## Product Change Notification

**PCN Number** : PCN142

**Reason For Change** : Change to the markings on H05VV-F 3x1.00mm<sup>2</sup> power cord.

**FIGURE-1**

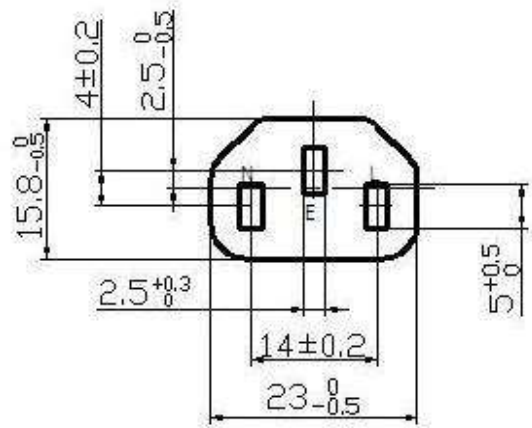
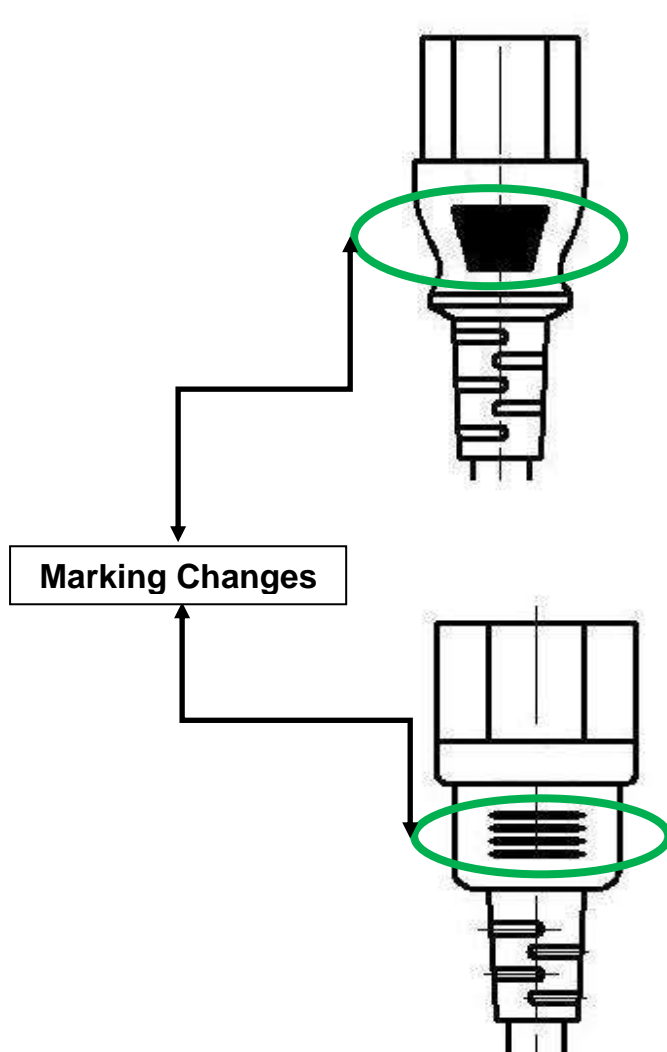
**Description of Change** : The markings on the over molding have changed due to a change in the cable partner used in the manufacturer of the power cord. All power cords have been manufactured in accordance with the International Standard IEC 60227. There is no change to the product specification.

The changes have been made to the markings on the over molding as shown below in Figure 1 and Figure 2.

Production Date	Cord Used : 2.00mts H05VV-F 3x1.00 mm <sup>2</sup> black
Original Marking	Cord branded QIAOTONG
JUN-2019	Cord brand changed to QIAOPU
NOV-2019	Cord brand changed to LIANSHENG
